Publication No. MB 3058-44
1/96

MODIFICATION INSTRUCTIONS

KODAK X-Omatic MULTILOADER 300

MODIFICATION No. 44

figure 1

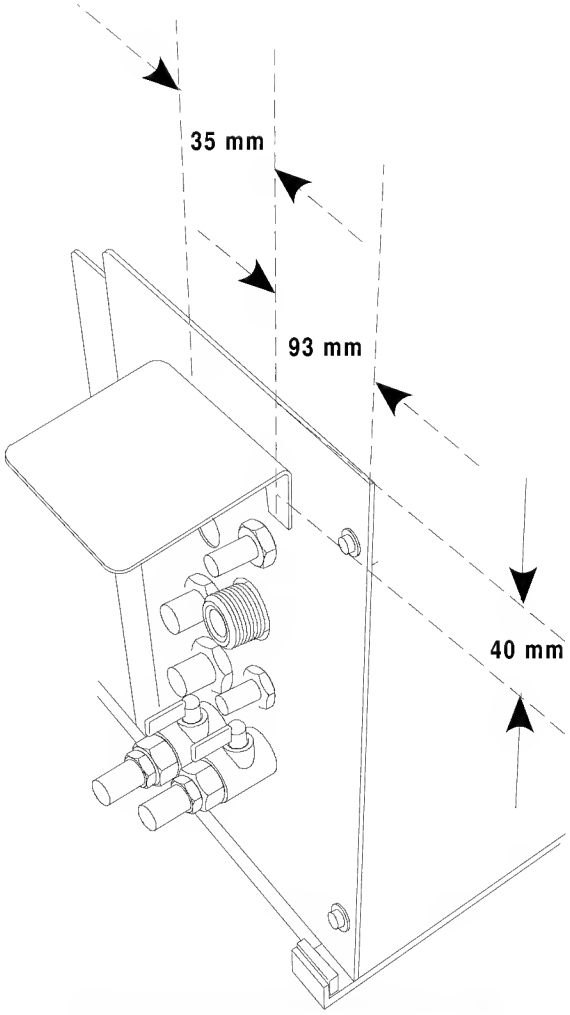
3. Mark the position of the 2 holes. See figure 1 on page 4.

4. Drill two 5 mm holes and remove all burrs.

5. Mount the PROTECTIVE PLATE. Use SCREWS, NUTS and WASHERS from the KIT.
